Access Compliance Report

Public Rights-of-Way

Intersection ID: 4731	Main Street: ARKLOW_RD	Cross Street: HARRINGTON_WOODS_RD	Location: NE
ADA ID: 0E00791CBD03	Ramp Type: Perp	Initial Pass/Fail: Fail	Overall Compliance: No
		Severity Score: 50

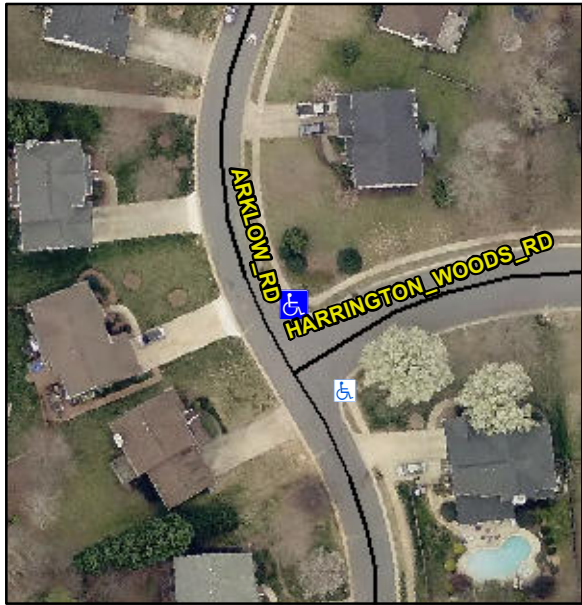
Codes/Mitigation Info/Possible Solution			Field Measurements/Component Compliance					
	Possible Solutions:		Compliance	Description	Data	Compliance	Description	Data
	Remove & Replace Entire Ramp.		N/A	Ramp Length (in)	48.0	No	Ramp Slope (%)	12.9
			Yes	Ramp Width (in)	48.0	No	Ramp XSlope (%)	7.8
			N/A	Flare Type LT	N/A	N/A	Flare Type RT	N/A
			N/A	Flare Slope LT (%)	N/A	N/A	Flare Slope RT (%)	N/A
			N/A	Flare Traversable LT?	N/A	N/A	Flare Traversable RT?	N/A
			N/A	Landing Length (in)	N/A	N/A	DWS Provided?	N/A
			N/A	Landing Width (in)	N/A	N/A	DWS Contrast?	N/A
			N/A	Landing Slope (%)	N/A	N/A	DWS Length (in)	N/A
			N/A	Landing X Slope (%)	N/A	N/A	DWS Full Width?	N/A
Surveyor Notes:		N/A	N/A	Landing Curb? (Y/N)	N/A	N/A	DWS Offset (in)	N/A
PROW/ADA:		Not Found, R304.2.2, R304.5.3	N/A	Shared Landing?	N/A			
			N/A	Gutter Ponding?	N/A	N/A	Gutter Slope (%)	N/A
			N/A	Gutter Lip Ht (in)	N/A	N/A	Gutter X Slope (%)	N/A

N/A	Painted X Walk1?	No	N/A	Painted X Walk2?	N/A
				X Walk 1 Direction	To S		X Walk 2 Direction	N/A
			N/A	X Walk 1 Width (in)	N/A	N/A	X Walk 2 Width (in)	N/A
				X Walk 1 Slope (%)	8.0		X Walk 2 Slope (%)	N/A
				X Walk 1 X Slope (%)	2.6		X Walk 2 X Slope (%)	N/A
			N/A	Ramp inside XWalk1?	N/A	N/A	Ramp inside XWalk2?	N/A
				Road Slope (%)	N/A	N/A	Clear Space?	N/A
				Road X Slope (%)	N/A	N/A	Clear Space to XWalk (in)	N/A
			N/A	Any Obstructions?	N/A	N/A	Storm Grate/Utility Hazard?	N/A
				Obstruction Type			Storm Grate/Utility Type	
					N/A			N/A
						Yes	Surface Condition? (G/P)	Good
Total Cost:		\$ 1850.00						
Street 1 Name HARRINGTON WOODS RD								
Stop Condition-Street 2 StopSign								
Street 2 Name N/A								
Stop Condition-Street 1 N/A
